UNITED STATES PATENT AND TRADEMARK OFFICE

APPLICATION NO.	FILING DATE	FIRST NAMED INVENTOR	ATTORNEY DOCKET NO.	CONFIRMATION NO.
10/688,663	10/16/2003	Norman Shendon	770C6-099006	1195
7590	11/08/2004		EXAMINER	NGUYEN, GEORGE BINH MINH
			ART UNIT	PAPER NUMBER
			3723	
DATE MAILED: 11/08/2004

Office Action Summary	Application No.	Applicant(s)	/
	10/688,663	SHENDON ET AL.	
	Examiner	Art Unit	
	George Nguyen	3723

DETAILED ACTION

0156746

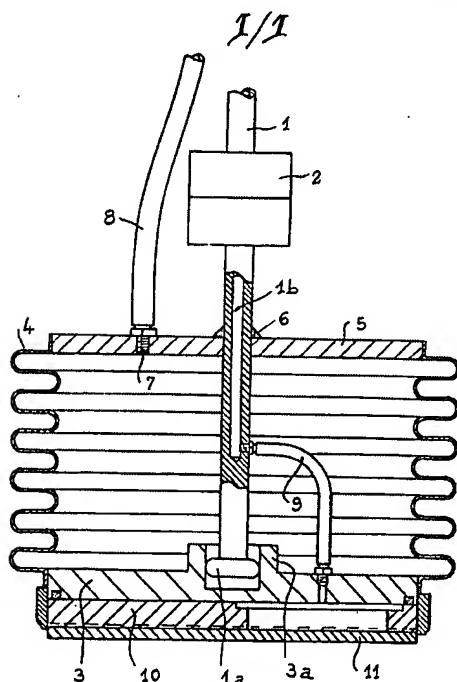
2. Claims 1, 4, 5, 7, 8, 10, 11, 15-18 are rejected under 35 U.S.C. 102(b) as being anticipated by EPO'156746.

With reference to Figure 1, EPO'746 discloses the claimed invention.

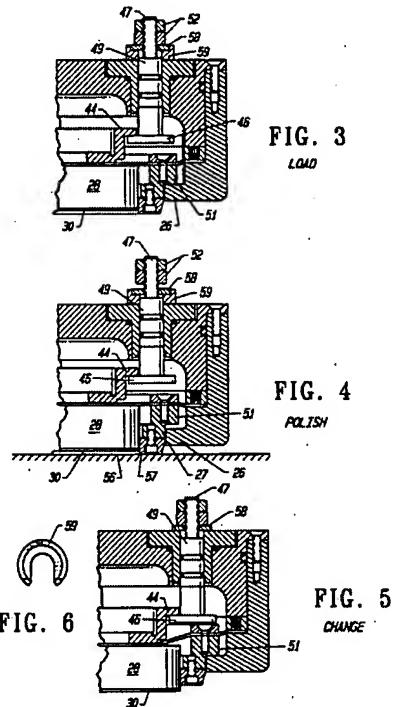
Claims 3 and 12 are rejected under 35 U.S.C. 103(a) as being unpatentable over EPO'746 in view of Shendon et al.'5,205,082.

EPO'746 has been discussed above, but does not disclose a retainer ring independently movable relative to the backing member.

With reference to Figs. 3-5, col. 5, line 46 to col. 6, line 10, Shendon discloses a wafer polishing head that enables a wafer retainer to float during polishing and yet independently extends beyond the backing member 28 to control the movement of wafer during polishing or changing the wafer.

Please note that Shendon teaches a 1st chamber 23 between housing 12 and backing member 28. The 2nd chamber is the volume underneath membrane 29.

Thus, it would have been obvious to one having ordinary skill in the art at the time the invention was made to have modified the polishing apparatus of EPO'746 with a retainer ring and 1st chamber and 2nd chamber as taught by Shendon to control the movement of the wafer.

Fig. 3A

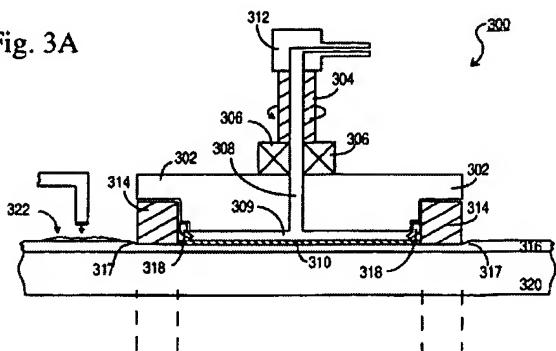
With reference to Fig. 3A, col. 4, line 25 to col. 5, line 25, Breivogel discloses the claimed invention.

Please note that the recess area 309 is the area created by lip seal 318 in combination with front surface of the backing area.

Thus, it would have been obvious to one having ordinary skill in the art at the time the invention was made to have modified the recess area of EPO'746 with the teaching of covering substantially the entire back surface of the substrate as taught by recess area 309 of Breivogel in order to provide a stronger holding force during polishing.

Regarding to claim 9, It would have been an obvious matter of design choice to have utilized O ring since applicant has not disclosed that O ring solves any stated problem or is for any particular purposes and it appears that the invention would perform equally well with a lip seal or O ring.
